MANCHESTER CITY NORTH STAND EXPANSION

GATE 3 ACCESS ROAD DESIGN CHANGES

GATE 3 ACCESS ROAD DESIGN CHANGES - MANCHESTER CITY NORTH STAND EXPANSION - DATE: 23.04.25

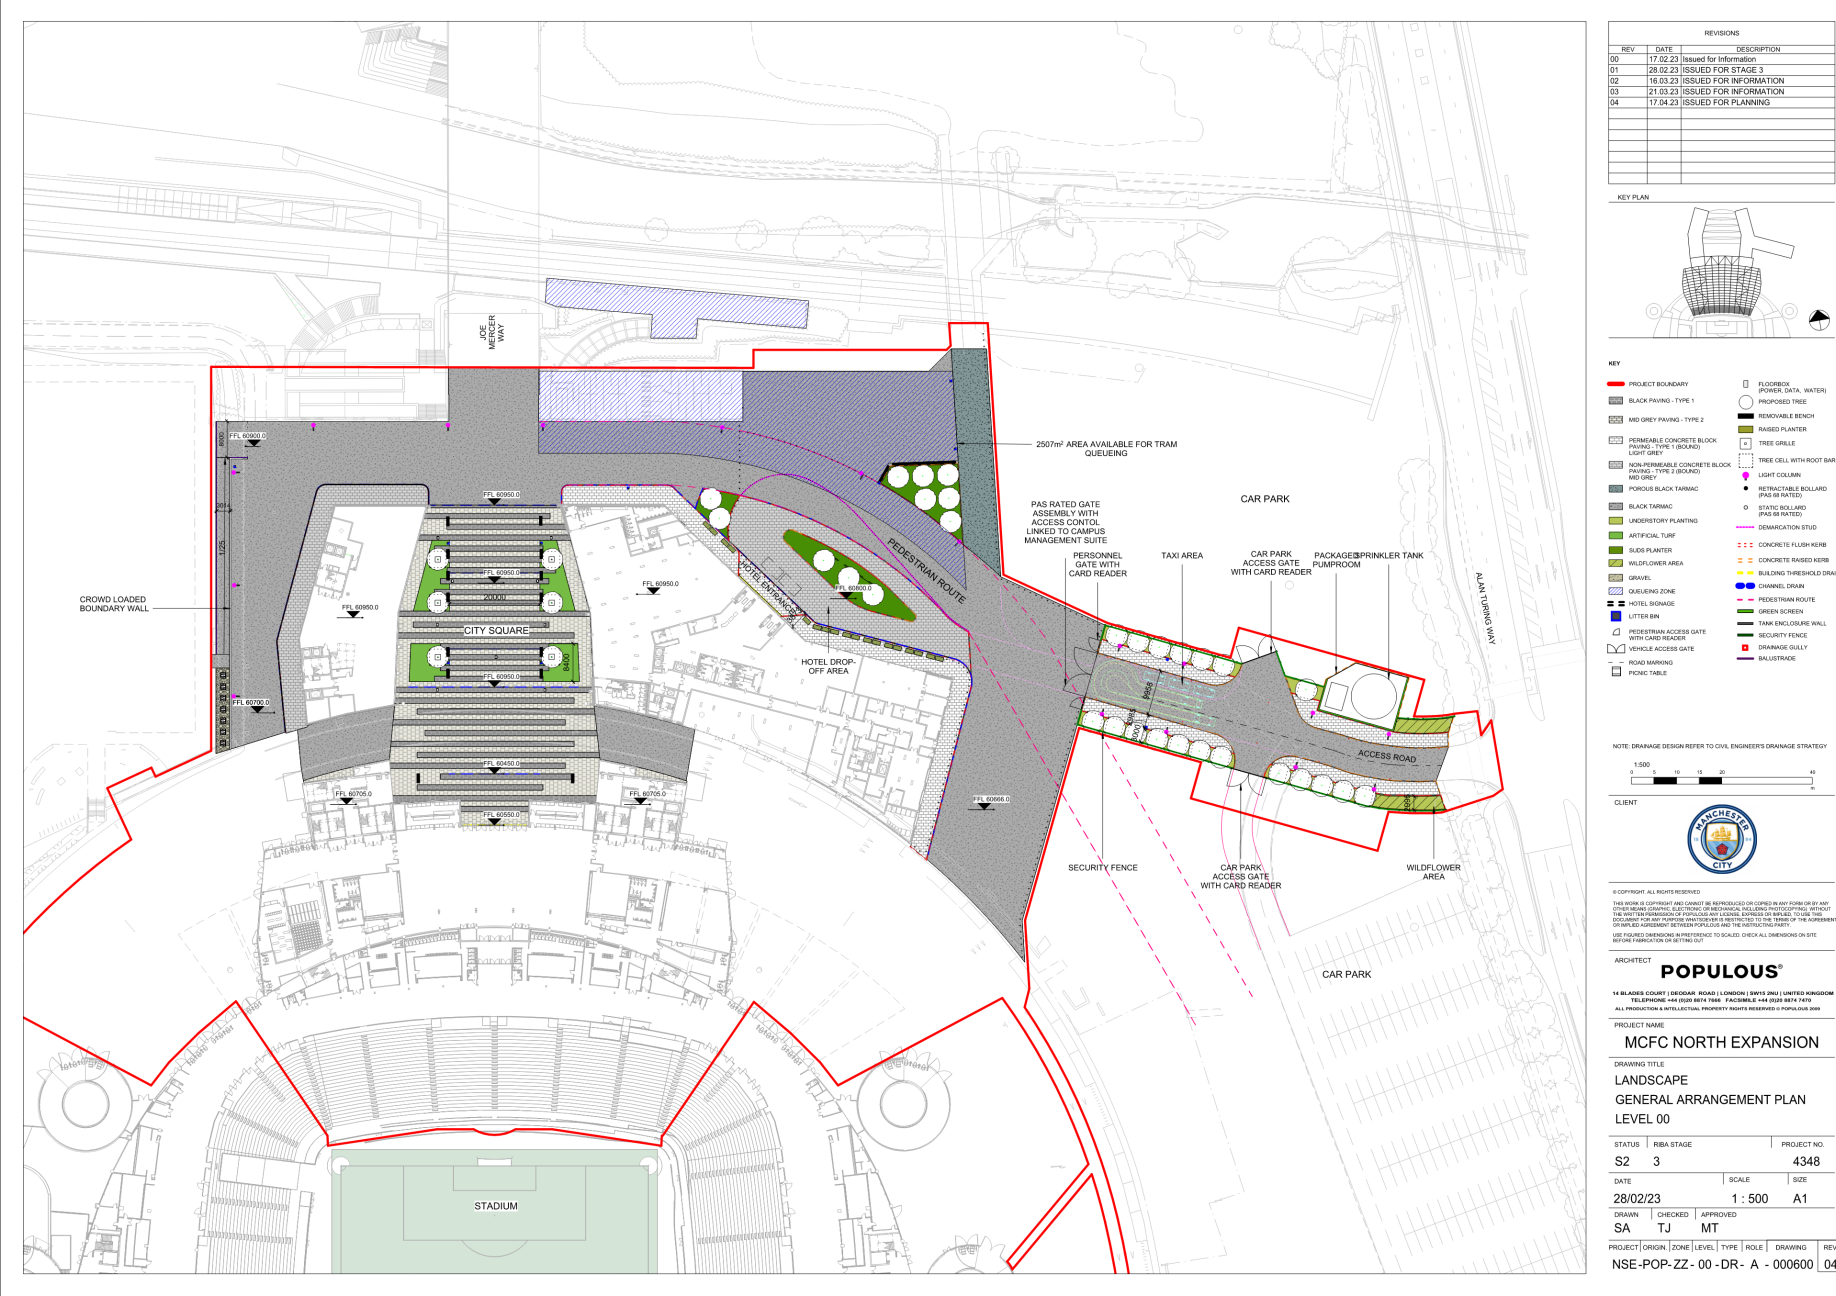
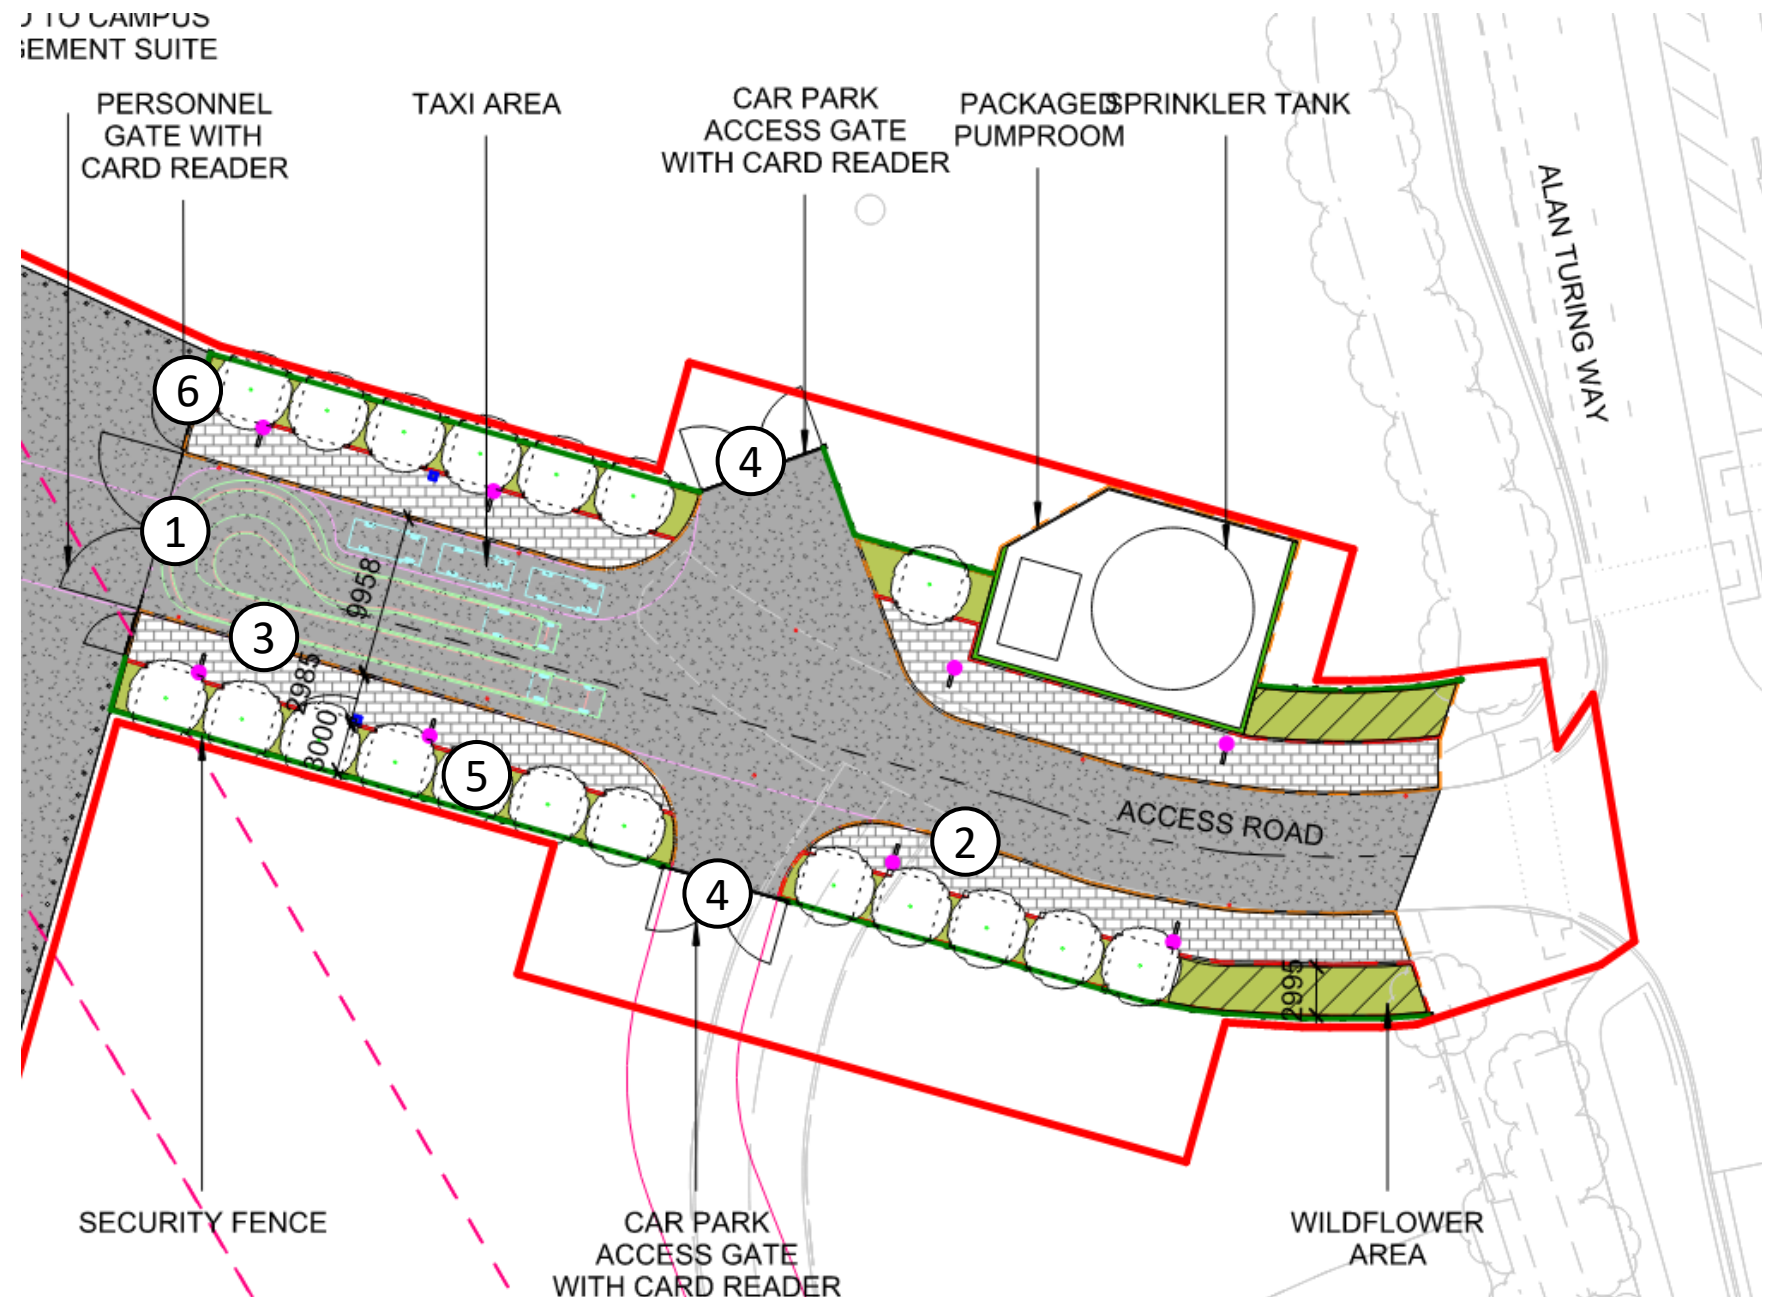
1. 2 pedestrian access gate with card reader + 1 vehicle gate.
2. Symmetrical pedestrian route on both sides of access road with 150mm raised kerb.
3. Pedestrian route width following Arup's tracking. (northwest of the access road)
4. Two Car Park access gates are with Card Reader.
5. 19 Trees.
6. 5 static bollards.

-
- HPU CABINETS
- ANPR CAMERA LOCATION TO BE COORDINATED WITH BELOW GROUND SERVICES
- PENDING APPROVAL ON BOLLARD LAYOUT
- SPRINKLER TANK
- CAR PARK ACCESS GATE MANUAL OPERATION
- PACKAGED PUMP HOUSE
- TAXI WAITING AREA
- BOUNDARY HARD AND SOFT LANDSCAPE TREATMENT TO BE CONFIRMED BY THE CLIENT
- ANPR CAMERA LOCATION TO BE COORDINATED WITH SITE SURVEY AND BELOW GROUND SERVICES
- ACCESS ROAD
- ROAD MARKING REVIEWING BY BH
- INTERCOM ISLAND WITH INTEGRATED TRAFFIC LIGHT SYSTEM
- LANDSCAPE WILDFLOWER TURF MOUNDS
- CAR PARK ACCESS GATE MANUAL OPERATION
- EXISTING FENCES
- ALAN TURING WAY
- 11149
- 4526
- 11149
- 10053
- 11800
- 2108
- 4800
- 8630
- 3700
- 8000
- 123
- 150
- 13
- 11
- 12
- 14
- 15
- 16
- 17
- POPULOUS
- Reduced or omitted
- New Addition
- Updated

DESIGN CHANGE REF NO.	ITEMS	REASON FOR CHANGE
1	No pedestrian gate within the red line boundary. Existing pedestrian gate at Alen Turing way will be used.	MCFC changed the access strategy of access road by retaining the existing vehicle and pedestrian gate at the Alan Turing way junction. Vehicle gate and pedestrian gate at west access road are not required.
2	Pedestrian route is restricted to the northside of the access road with 125mm raised kerb.	The existing pedestrian gate is only on the north side. Therefore the north side is designated pedestrian route which aligns with the pedestrian crossing facilities on the Alan Turing Way. This pedestrian route has 125mm raised kerb and color contrasting tactile paving. The south side is converted to vehicle layby zone with flush kerb.
3	Southern side of the paving now flush with road level for vehicle access over, concrete subbase amended to receive additional loading.	As there is no pedestrian gate in the south side at Alan Turing way junction, the southside of the access road is changed from pedestrian to vehicle layby area with flush kerb. The paving subbase design is updated according to take required vehicle loading.

4	1 intercom island with dual height intercom column and Trief kerb are added.	The intercom island is added because of the access control strategy required by MCFC. The dual height column suits both standard car and coach. color contrasting trief kerb is added for vehicle mitigation purpose.
5	Intercom Island to incorporate additional ducting to bollard control units.	The additional ducting to bollard control unit is added to fit intercom requirement.
6	Pedestrian route width at the northwest and southwest are reduced and the access road is increased to accommodate BH's vehicle tracking.	The increase of the road width follows vehicle tracking review with the civil engineer following the requirement from MCFC.
7	ANPR camera added.	ANPR camera is added as a part of security requirement from MCFC .
8	Access control to the carparks and main pedestrian gates removed.	The removal of the access control to the car parks and main pedestrian gate due to the access management strategy change from MCFC.

9	Ducts retained to North Car park gates for future access.	Requirement from MCFC.
10	The length of sprinkler tank enclosure is increased.	The sprinkler tank enclosure is extended to fit the updated sprinkler tank layout.
11	Static bollards are increased to 11 and 6 retractable bollards are added.	The bollard arrangement was reviewed together with the vehicle tracking on the updated access road design. The bollard arrangement fit the access road width and vehicle tracking requirement.(Retractable bollards are required for vehicle access)
12	Additional static bollards (2 No) at either end of main entrance to GATE 3 to cover area of sloped face to bunds.	The interface between the bollard and sloping green mound is updated. Additional static bollards are added to ensure it meet the security requirement.
13	Traffic lights incorporated to intercom bollard.	Required for access management.
14	Tree number at the Access road reduced from 19 to 12.	The revised access road arrangement proposes reduction in numbers of new trees lining the access road. The consented scheme proposed 19 trees, our revised proposal includes for 12 trees. The reduction provides an increase to the available spacing between trees from 5 metres to 7 metres. The wider spacing will support healthier tree growth by minimizing crowding in the long term, allowing each tree greater access to soil volume and nutrients. Additionally, the increased distance will enable trees to grow larger, enhancing the visual impact along the access road. The proposed reduction in tree number does not affect MCC's 1:3 replacement target as 9 existing trees have been removed and 29 new are intended under the current proposal.

15	Tree root barrier added in lieu of Tree cell root space structure.	Tree cell root space structure is not required as all trees are located in the soft landscape area and there is sufficient soil volume and no loading requirement.
16	Removal of BUS kerb, replaced with standard kerb in front of sprinkler tank base, due to no requirement for vehicle access to this footpath area.	The bus kerb was introduced to protect the sprinkler tank enclosure from vehicles on the adjacent access road. With the introduction of the designated pedestrian route with 125mm raised kerb on the north side in the updated design, this bus kerb is no longer required.
17	Road marking is added.	Road marking is added following civil engineer's design update.
